Access Compliance Report Public Rights-of-Way (Curb Ramps)

Intersection ID: 31896Main Street: GREEN_MOUNTAIN_RDCross Street: SHOPTON_RD_WESTLocation:NWADA ID: A40CC0DB7E6FRamp Type: PerpDiagInitial Pass/Fail: FailOverall Compliance: NoSeverity Score:10

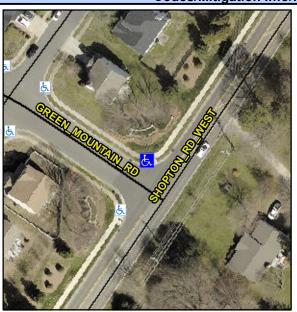
Not Found, R304.5.1, R304.5.3

r leid Measurements/Component Compnance						
	Comp	Compliance Description		Comp	liance Description	Data
	N/A	Ramp Length (in)	48.0	Yes	Ramp Slope (%)	5.3
	No	Ramp Width (in)	47.0	No	Ramp XSlope (%)	2.8
	N/A	Flare Type LT	N/A	N/A	Flare Type RT	N/A
	N/A	Flare Slope LT (%)	N/A	N/A	Flare Slope RT (%)	N/A
	N/A	Flare Traversable LT?	N/A	N/A	Flare Traversable RT?	N/A
	N/A	Landing Length (in)	N/A	N/A	DWS Provided?	N/A
	N/A	Landing Width (in)	N/A	N/A	DWS Contrast?	N/A
	N/A	Landing Slope (%)	N/A	N/A	DWS Length (in)	N/A
	N/A	Landing X Slope (%)	N/A	N/A	DWS Full Width?	N/A
	N/A	Landing Curb? (Y/N)	N/A	N/A	DWS Offset (in)	N/A
	N/A	Shared Landing?	N/A			
	N/A	Gutter Ponding?	N/A	N/A	Gutter Slope (%)	N/A
	N/A	Gutter Lip Ht (in)	N/A	N/A	Gutter X Slope (%)	N/A
	N/A	Painted X Walk1?	No	N/A	Painted X Walk2?	No
		X Walk 1 Direction	To SW		X Walk 2 Direction	To SE
	N/A	X Walk 1 Width (in)	N/A	N/A	X Walk 2 Width (in)	N/A
		X Walk 1 Slope (%)	0.7		X Walk 2 Slope (%)	1.2

Remove & Replace Curb Ramp With
Two New Directional Ramps or
Equivalent.
